Fluence Issues for PWR Internals

Public Meeting on MRP-227, Rev.1
March 31, 2015

Radial Heat Generation Figure of Merit, F

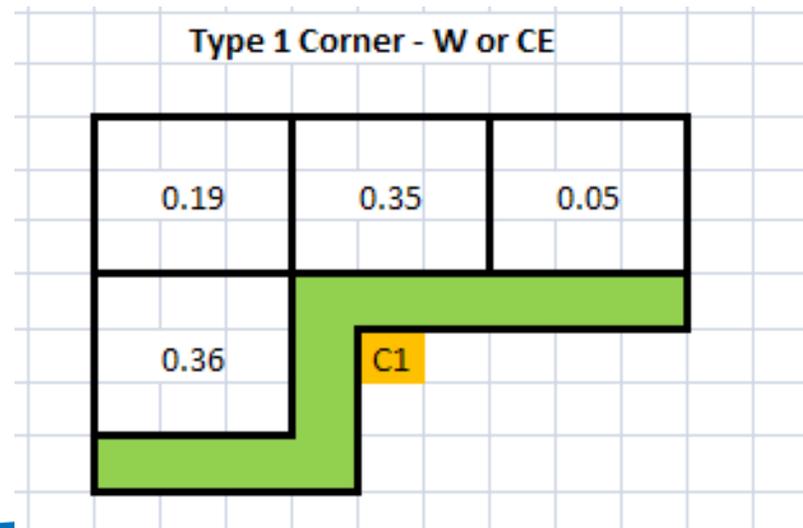
- Method of determination of the generic fluence estimates
- Basis for reliance on core average power density as a figure of merit,
- Basis for scaling with only the peripheral assembly power (as opposed to 2 or 3 assemblies in) for determining figure of merit “F” related to radial component applicability
